Mr. William Cody, Inspector  
Arkansas Department of Energy and Environment, Office of Water Quality  
5301 Northshore Drive  
North Little Rock, AR 72118

**RE: NPDES Permit AR0021865; AFIN 08-00036**

On November 9, 2023, a Compliance Evaluation Inspection was performed for the Eureka Springs, Arkansas wastewater treatment facility. MCE and the city offer the following responses to the four (4) items outlined in the "Summary of Findings" contained in the inspection report:

CITY OF EUREKA SPRINGS, ARKANSAS		PHASE 1 - TREATMENT PLANT UPGRADE	
REVISED SITE PLAN			
USI Consulting Engineers	Springdale, Arkansas	JOB NO. 0509068	DATE 11/07/07
SCALE: 1"=30'	DRAWN: JLM	CKD: TWC	SHEET: 100A

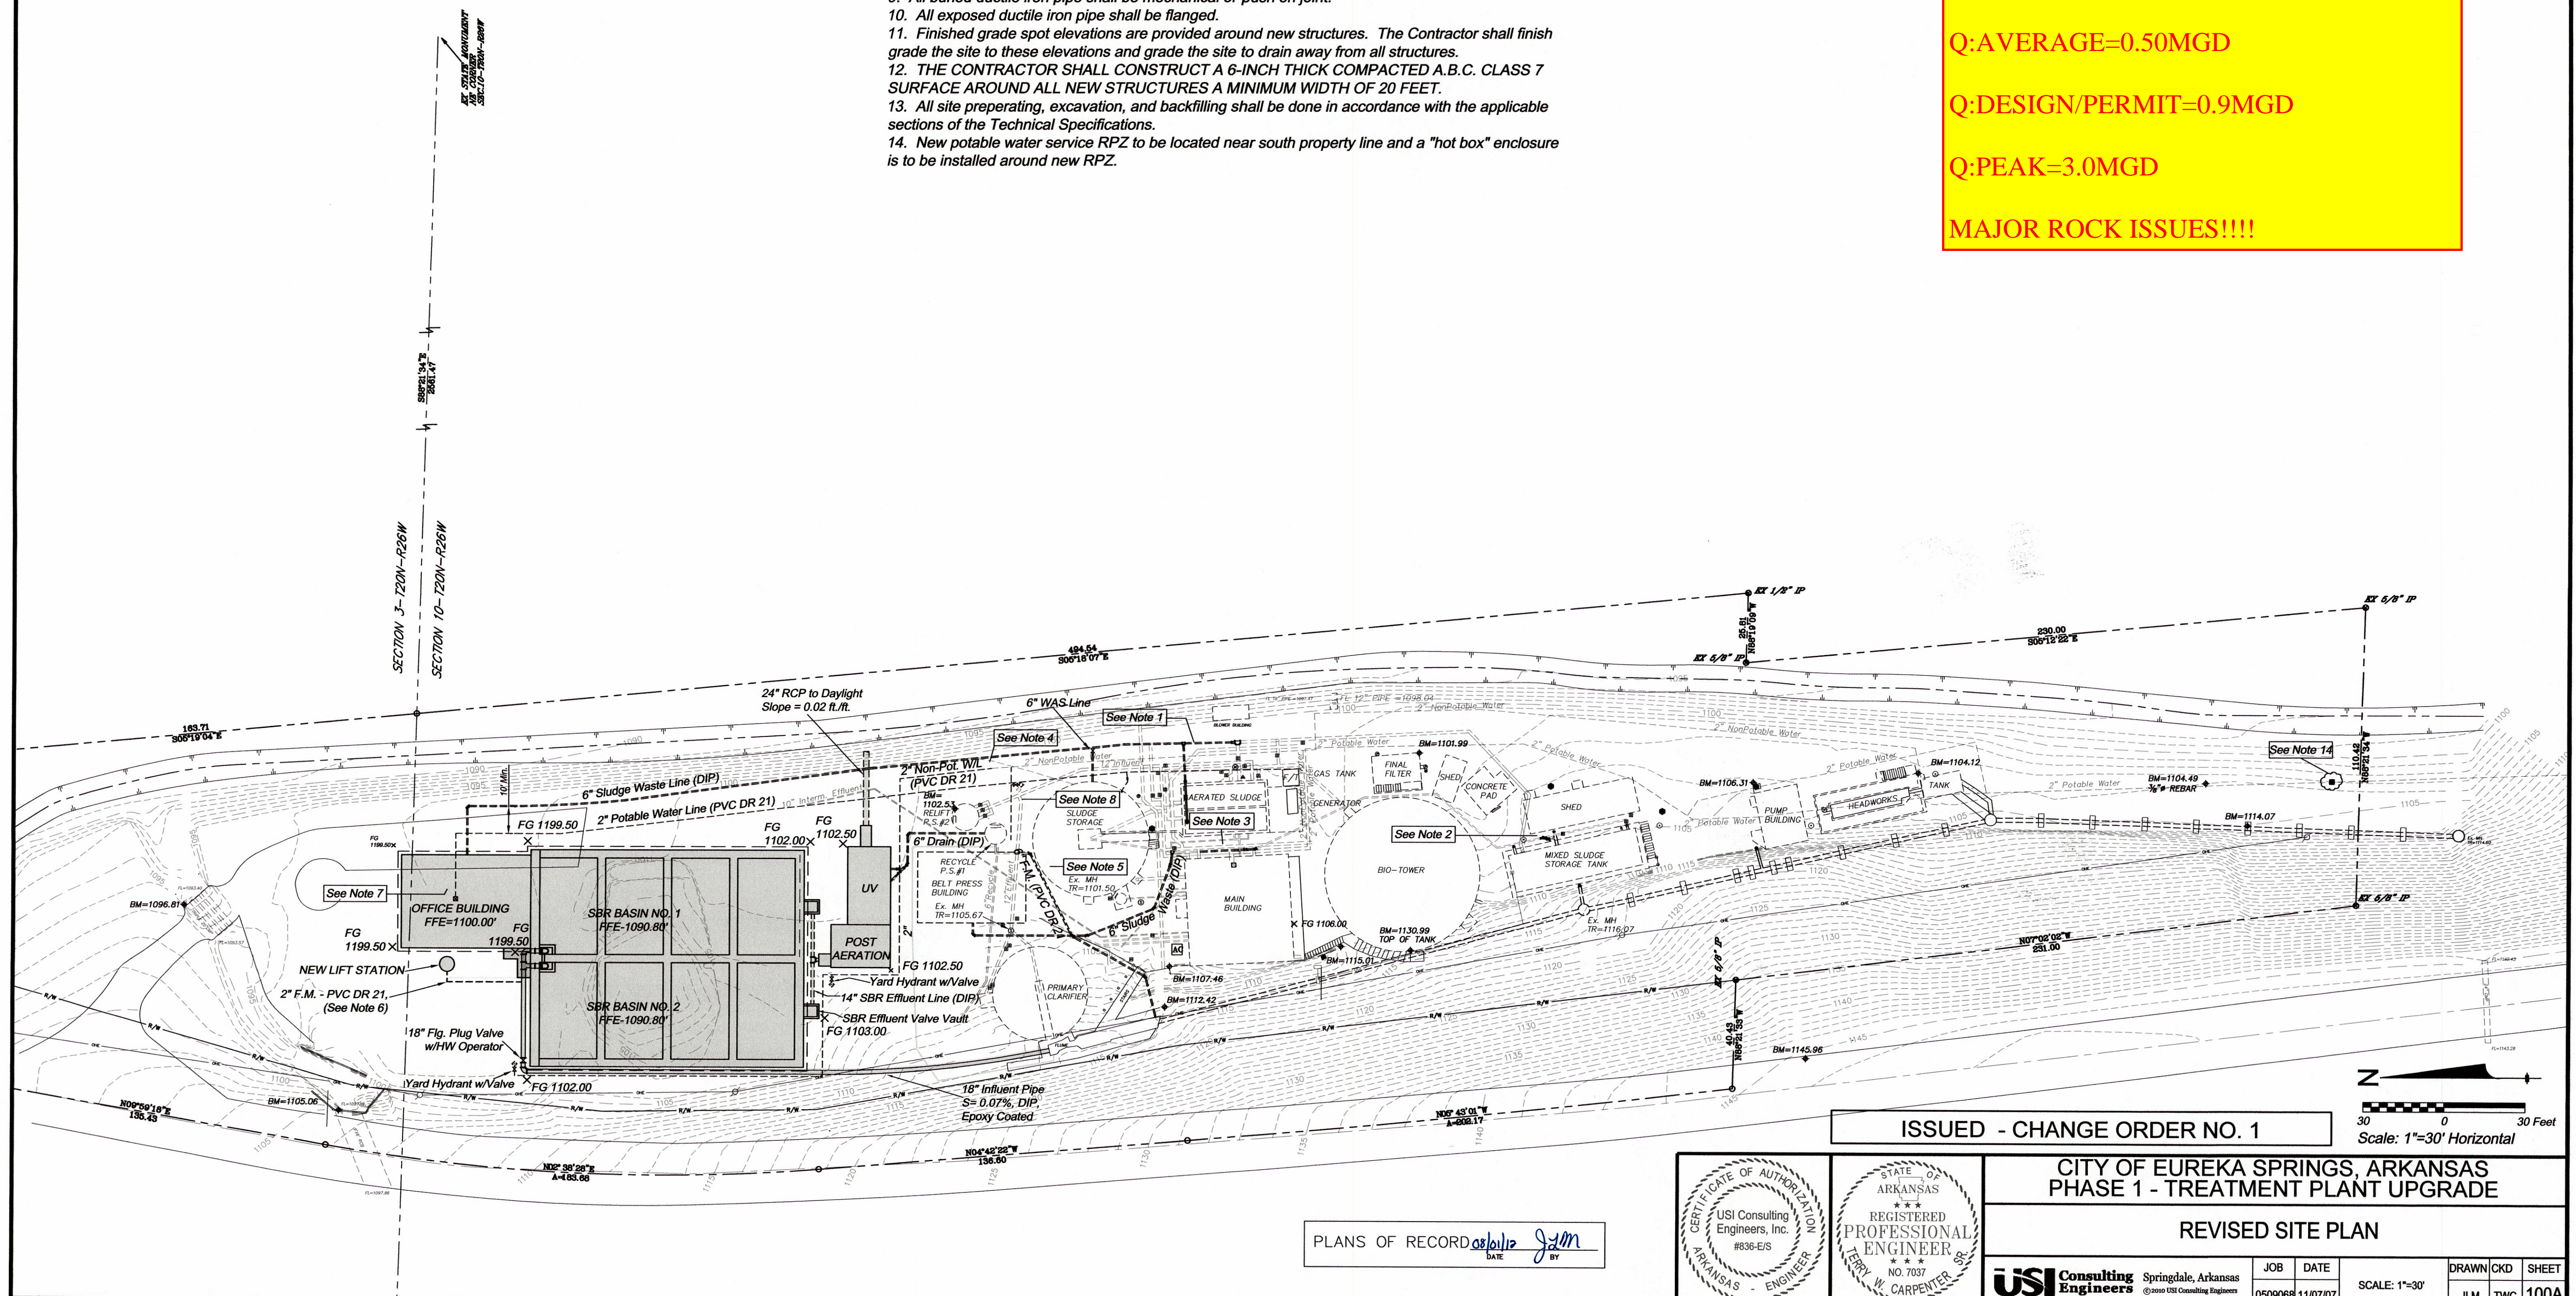
Greetings. As you may know, McClelland Consulting Engineers has been retained by the City of Eureka Springs to assist in evaluation of the existing wastewater treatment plant and response to inquiries from your agency. In addition to the previous responses to comments, MCE is working on an overall WWTP assessment and recommendations for expansion/renovation. The proposed improvements have been previously provided. An exhibit with markups and callouts of the proposed improvements is included with this letter as Attachment A.
